Staff Report & Recommendation

Historic Preservation Board

SUBJECT: HPB23-0592, **624 Collins Avenue.**

The applicant has submitted plans entitled "Isabelle's Restaurant", as prepared by Beilinson Gomez Architecture, dated September 11, 2023.

1923 Photograph

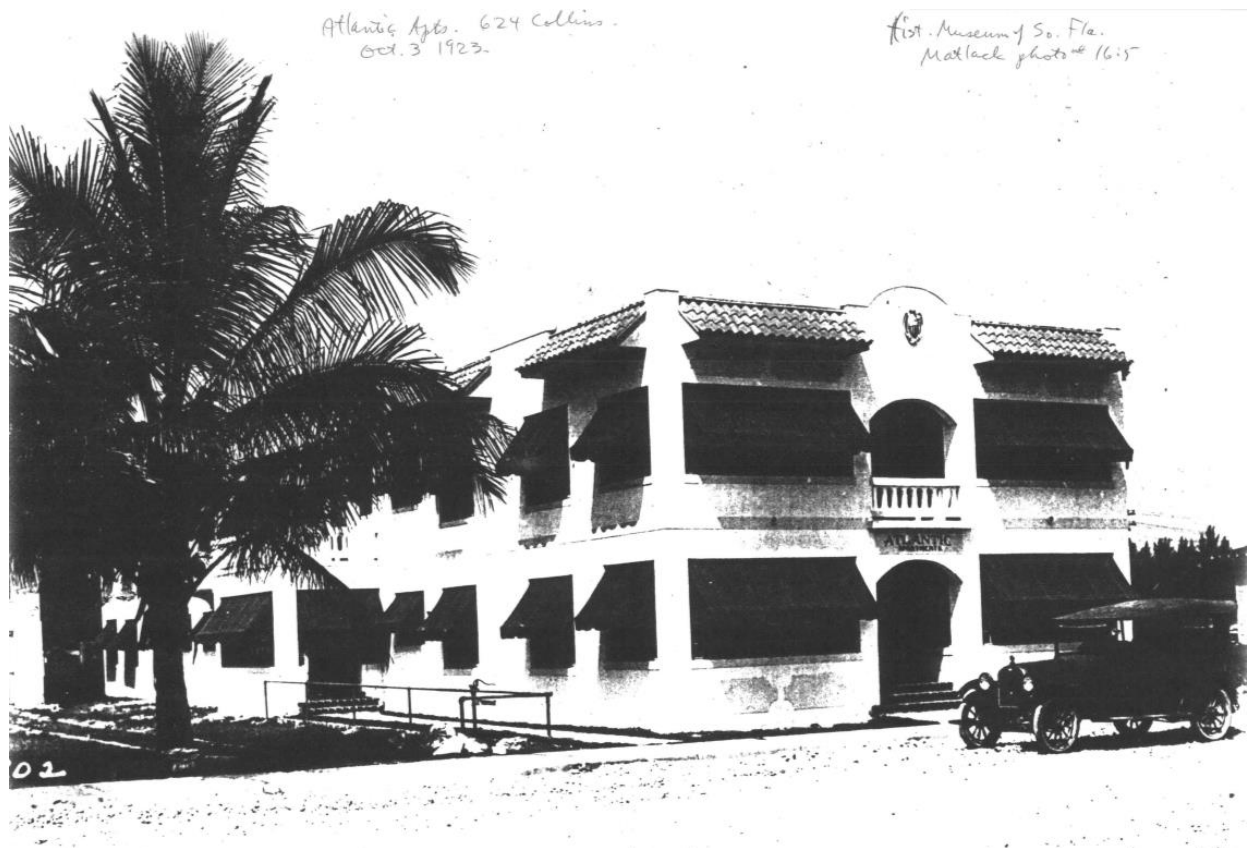
- a. Exterior architectural features.
Not Satisfied
The modification of the opening at the second level along Collins Avenue is not consistent with the original design and has an adverse impact on the proportionality of the primary façade.

Staff has only two concerns relative to the proposed project. First, in order to address the Sea Level Rise and Resiliency Criteria, staff recommends that the applicant explore raising the lower rear portion of the first-floor level (currently 6.68' NGVD) to match the higher elevation at the front of the building (8.00' NGVD); to make the building less susceptible to the effects of future sea level rise. Second, at the second level of the Collins Avenue façade, the applicant is proposing to enclose the open-air porch including the removal of the existing decorative balustrade. Although the balustrade is not original, it was designed in a manner somewhat consistent with historical documentation. Staff has no objection to the proposed enclosure of the porch with glass but does recommend that a new balustrade be introduced on the outside of the glass that more closely resembles to the original design in order to maintain the proportions of the primary façade

- b. A new balustrade shall be introduced on the outside of the proposed storefront glass enclosure at the second level along Collins Avenue in a manner consistent with available historic documentation, in a manner to be reviewed and approved by staff consistent with the Certificate of Appropriateness Criteria and/or the directions from the Board.
